Re: StarBucks

8721 Washington NE Traffic Circulation Layout

Architect's Response Letter

Project: Starbucks – Alameda & Washington

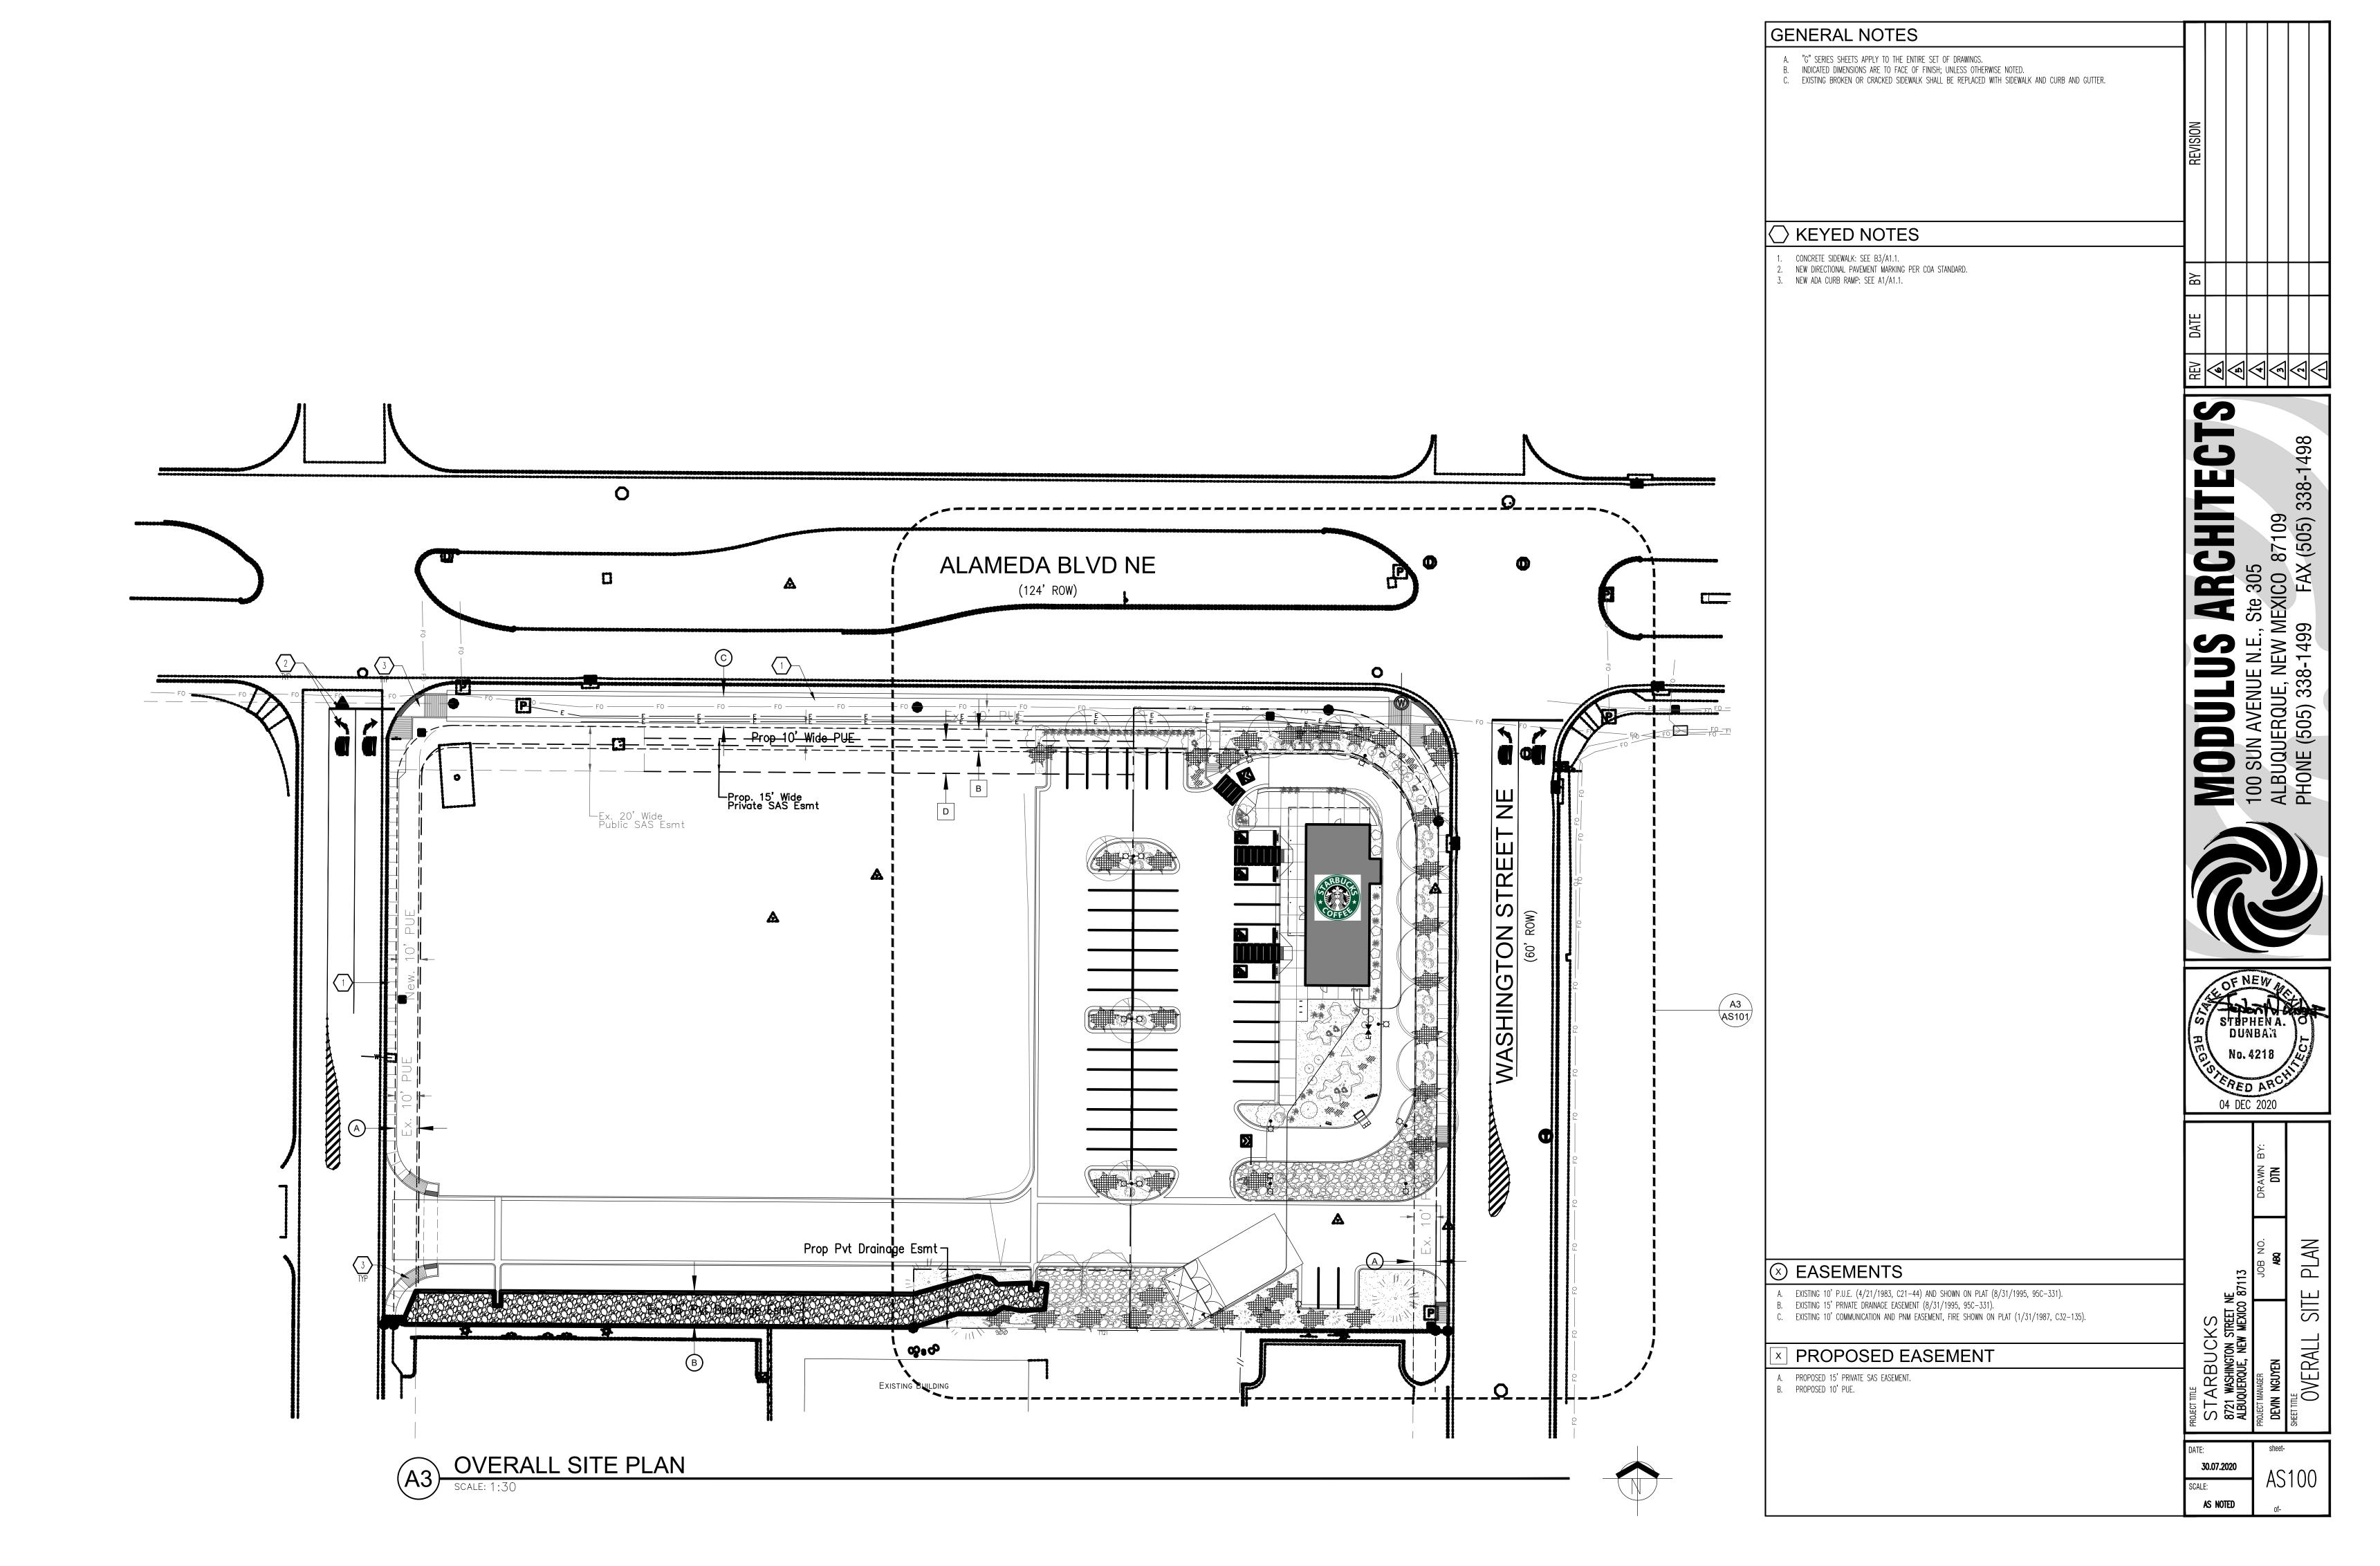
1. Traffic Circulation layout must be stamped, signed, and dated by an engineer or architect licensed in the state of New Mexico.

Refer revised site plan sheet AS101 and Site Details sheet A1.1.
